Statement of Environmental Effects

**Section 4.55(8) Modification
to Development Consent
2017/0402**

**12 Storey Mixed Use Development
1 Butler Road, Hurstville**

February 24, 2023

Figure 6: Proposed Consolidated Fire Stair (Level 3 Floor Plan – Typical of Fire Stair Modification)

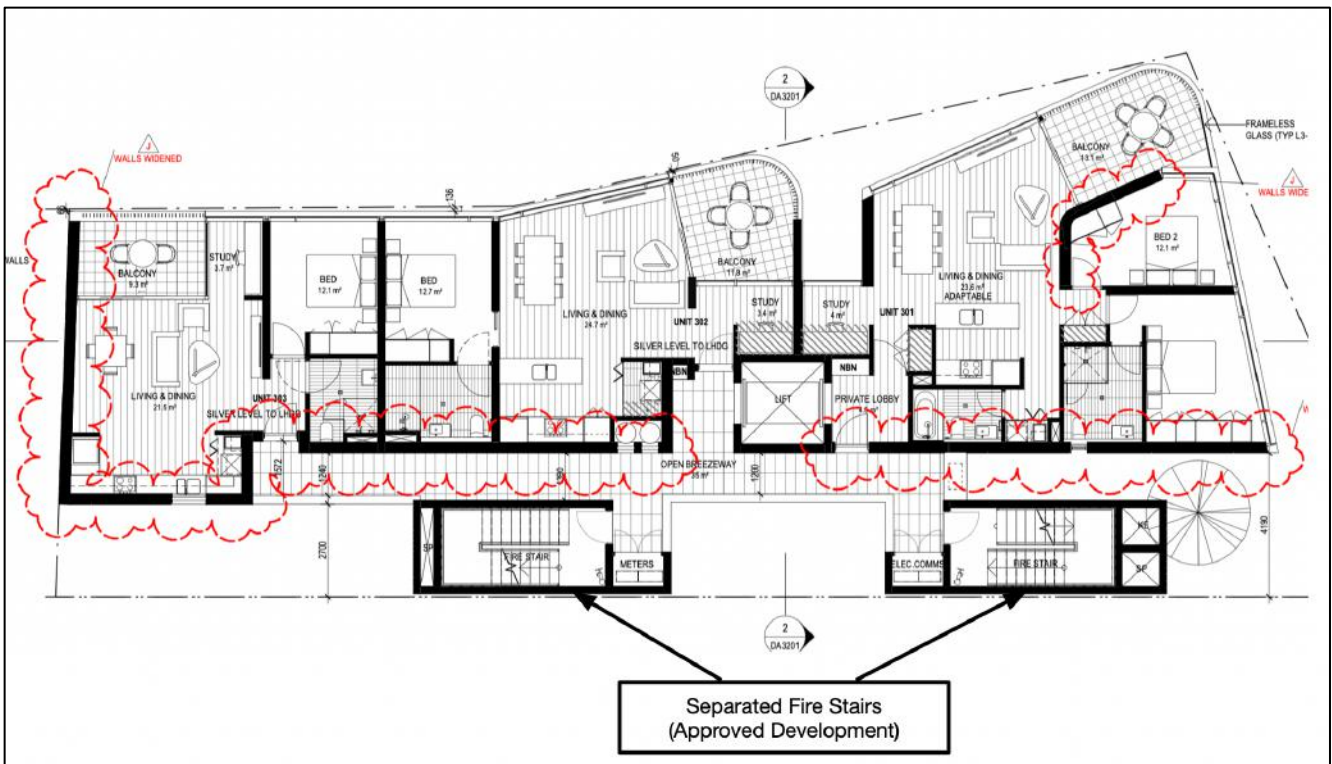
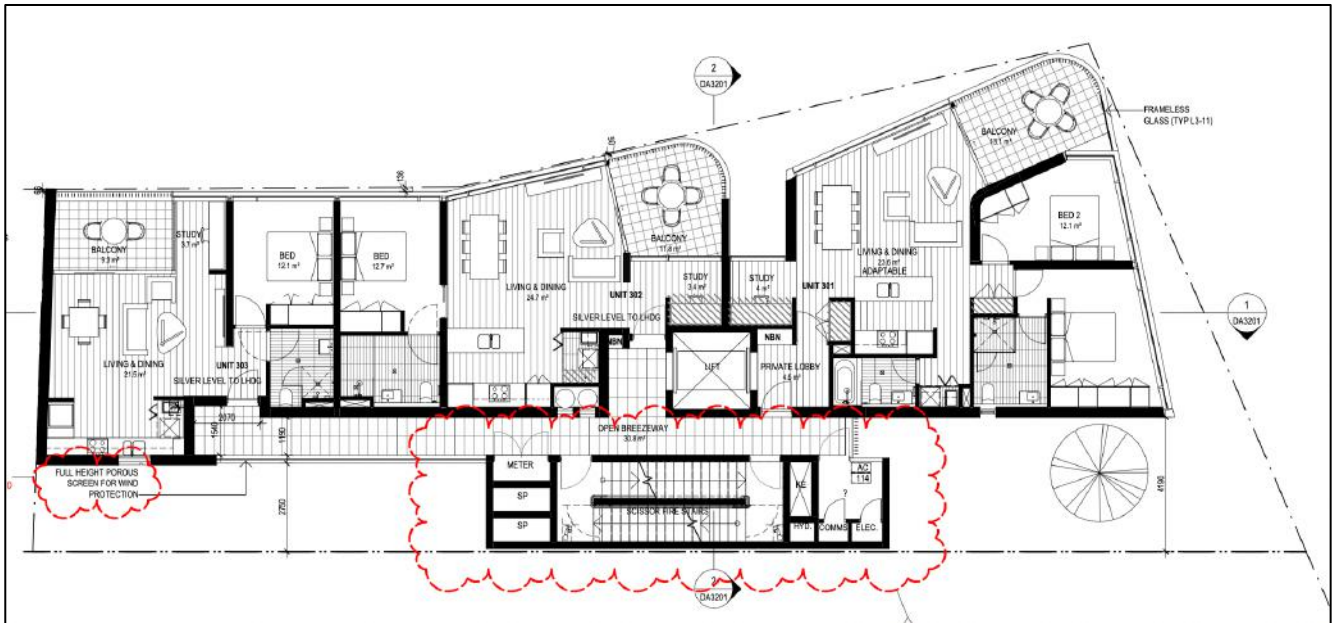
2. The subject application proposes to modify the southern fire stair egress. The approved plans provide for two separate fire stairs. This Application seeks to modify that arrangement to instead provide a consolidated fire stair in a scissor configuration. Arising from the reconfigured fire stair, the application also proposes a number of related and consequential amendments to the approved plans. These include minor reconfiguration of the ground and first floor plans to provide additional toilets, utility and storage areas within part of the area occupied by the approved eastern fire stair. Also proposed as amendment to the southern elevation, is the provision of a porous screen for wind protection which will protect the southern side of the open breezeway which, under the approved plans, is afforded wind protection by the westernmost of the two fire stairs.

- The subject modification proposes to consolidate the two first stairs on the southern side of the approved building, within a consolidated fire stair in scissor configuration. Figure 6 and Figure 7 show the proposed fire stair arrangement in plan view and elevation respectively.

Figure 8: Juxtaposition of Approved and Proposed Ground Floor Plan

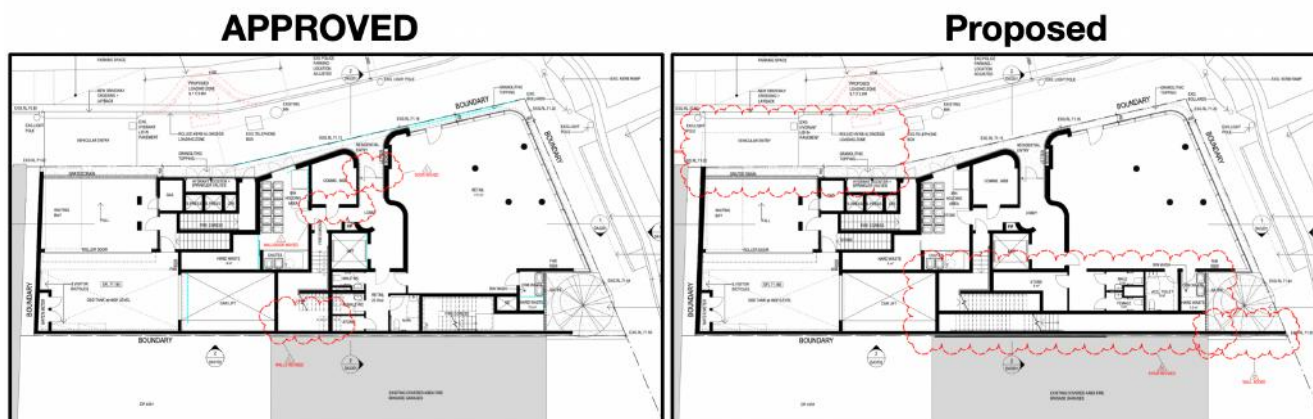
18. The consolidation of the 2 approved fire stairs into a single scissor stair requires minor internal layout changes at ground and first floor. These amendments include relocation of the ground floor toilets servicing the retail tenancy, reconfiguration of utility rooms and the provision of a new storeroom to

service the ground floor retail tenancy. The approved and proposed ground floor plans are provided in juxtaposition in Figure 8.

Figure 11: Comparison of Approved and Proposed Breezeway Design

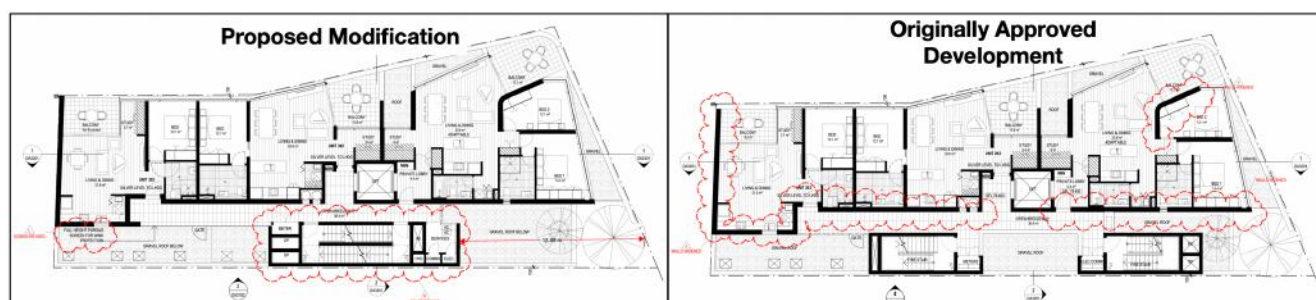
65. The modified development involves the same end closure of the breezeways. The difference between the originally approved development and the proposed modification relative to breezeways is twofold; the length and second the additional wind protective enclosure. The breezeways at Levels 2 and above as approved and proposed area shown in the following Figure 11.

66. Noting that the width of the breezeway is identical in both proposals, the difference in terms of length is:

| Originally Approved | Proposed Modification | Difference |
|--|---------------------------------|--|
| Two breezeways of 7.24m and 7.94m in length, separated by 6.25m. Total breezeway length is 15.18m. | One breezeway of 11.42m length. | Total breezeway length is reduced by 3.76m. The length of any single breezeway is increased by 3.48m. |
